Proposal for Supplement 7 to the 06 series of amendments to Regulation No. 16 (Safety-belts)

The text reproduced below was prepared by the expert from the European Association of Automotive Suppliers (CLEPA), to introduce provisions for a new fixture to verify space availability of universal lateral facing Child Restraint Systems (CRS) "lie-flat". It is based on a document without symbol (GRSP-57-07-Rev.1) distributed at the fifty-seventh session of the Working Party on Passive Safety (GRSP). The modifications to the current text of UN Regulation No. 16 are marked in bold for new or strikethrough for deleted characters.

Figure 7

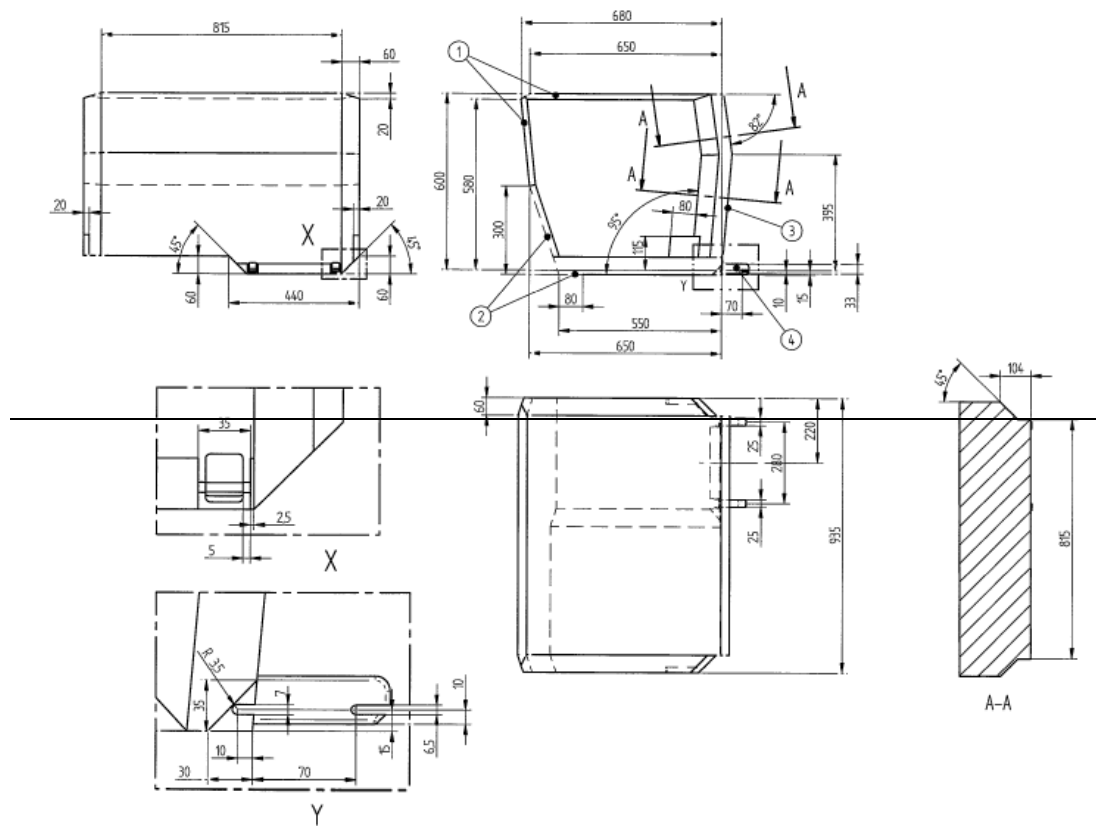
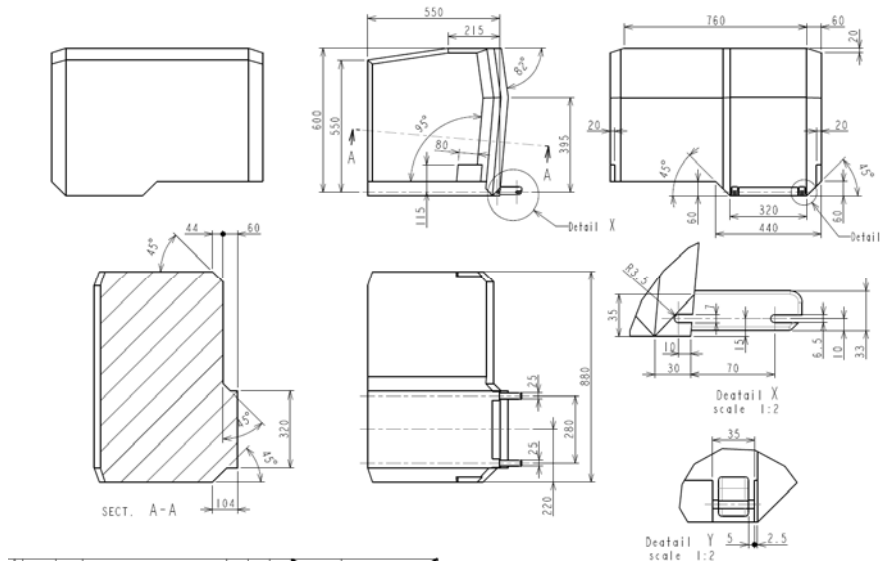
Paragraph 4.7., amend to read:

"4.7. Lateral facing child restraint systems envelope

Envelope dimensions for lateral facing position CRS – ISO/L1- ISOFIX SIZE CLASS F or symmetrically opposite – ISO/L2 – ISOFIX CLASS G
